# Access Compliance Report

## Public Rights-of-Way

### (Curb Ramps)

Intersection ID: 23437	Main Street: TRYON_ST	Cross Street: MOSS_LN	Location:	E
ADA ID: 80EB002D919D	Ramp Type: MedianPerp	Initial Pass/Fail: Pass	Overall Compliance: No	Severity Score: 5.25
Codes/Mitigation Info/Possible Solution		Field Measurements/Component Compliance

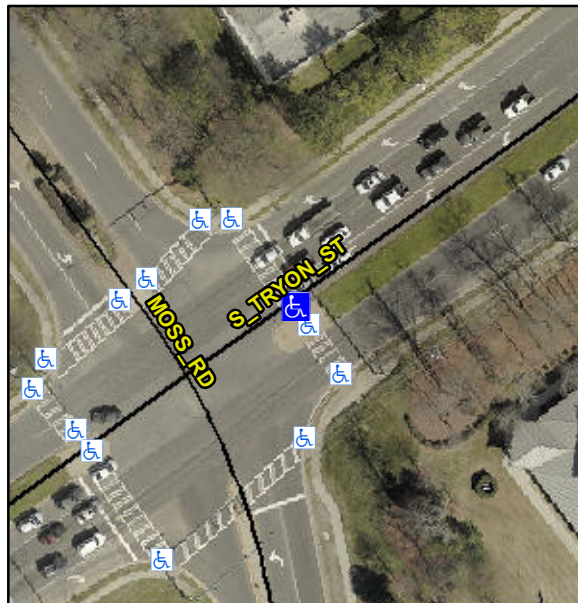
**Not Found, R304.5.3, R304.2.1,  
R302.7, R304.5.4**

Compliance	Description	Data	Compliance	Description	Data
N/A	Ramp Length (in)	64.0	Yes	Ramp Slope (%)	5.4
Yes	Ramp Width (in)	48.0	No	Ramp XSlope (%)	2.2
N/A	Flare Type LT	Sloped	N/A	Flare Type RT	N/A
N/A	Flare Slope LT (%)	4.3	Yes	Flare Slope RT (%)	3.7
N/A	Flare Traversable LT?	Yes	N/A	Flare Traversable RT?	Yes
No	Landing Length (in)	36.0	Yes	DWS Provided?	Yes
Yes	Landing Width (in)	48.0	Yes	DWS Contrast?	Yes
Yes	Landing Slope (%)	0.6	Yes	DWS Length (in)	25.5
Yes	Landing X Slope (%)	0.9	Yes	DWS Full Width?	Yes
N/A	Landing Curb? (Y/N)	N/A	Yes	DWS Offset (in)	0.0
N/A	Shared Landing?	Yes			
No	Gutter Ponding?	Yes	No	Gutter Slope (%)	6.9
Yes	Gutter Lip Ht (in)	0.0	Yes	Gutter X Slope (%)	1.2
N/A	Painted X Walk1?	Yes	N/A	Painted X Walk2?	N/A
	X Walk 1 Direction	To N		X Walk 2 Direction	N/A
N/A	X Walk 1 Width (in)	119.0	N/A	X Walk 2 Width (in)	N/A
	X Walk 1 Slope (%)	2.4		X Walk 2 Slope (%)	N/A
	X Walk 1 X Slope (%)	1.0		X Walk 2 X Slope (%)	N/A

**Remove & Replace Entire Ramp.  
Remove & Replace Gutter.**
